BULLETIN NO. 090507

PRODUCT: All 95M-200 Boilers

TITLE: Line Voltage Monitor

PHOTO 1

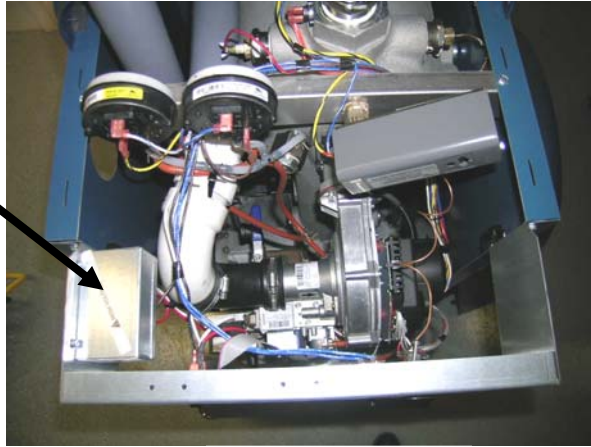
Starting with boilers manufactured May 1, 2009, the Line Voltage Monitor is installed as standard equipment, See photos 1 & 2.

A “Line Voltage Monitoring” control has been developed to insure that the Honeywell MCBA operates only under full power. The operation of this line monitoring device is to insure that proper power is supplied to the Honeywell MCBA control. In the event the incoming power approaches unacceptably low levels, the line monitor will shut down power to the control preventing operation and preventing an E-04 hard lockout.
